**Buffalo Urban Development Corporation RFP for Architectural & Engineering Consulting,  
Project Inspection Services and Grant Administration Services for Northland Corridor  
Redevelopment Phase 3**

**Question and Answers Summary**

*(As of January 9, 2023 at noon)*

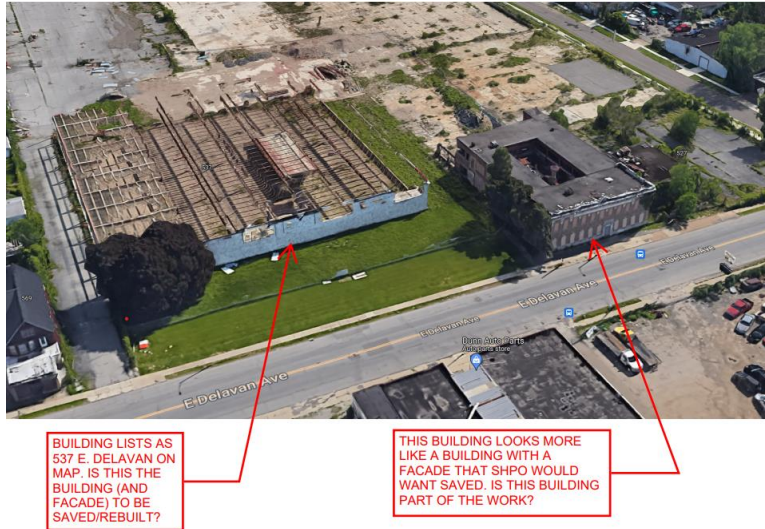
**Q: One thing I wanted to clarify is exactly which building on East Delevan is to be part of the project. I assume it is the one on the left in the attached aerial, but the façade on the smaller building made me question that. Can you clarify?**

A: The building on the left is in the project scope. However, the building is mostly demolished with new structural steel added. The façade of the building on the right needs to be maintained, per New York State Historic Preservation Office (SHPO), of which is outside the scope of this RFP.
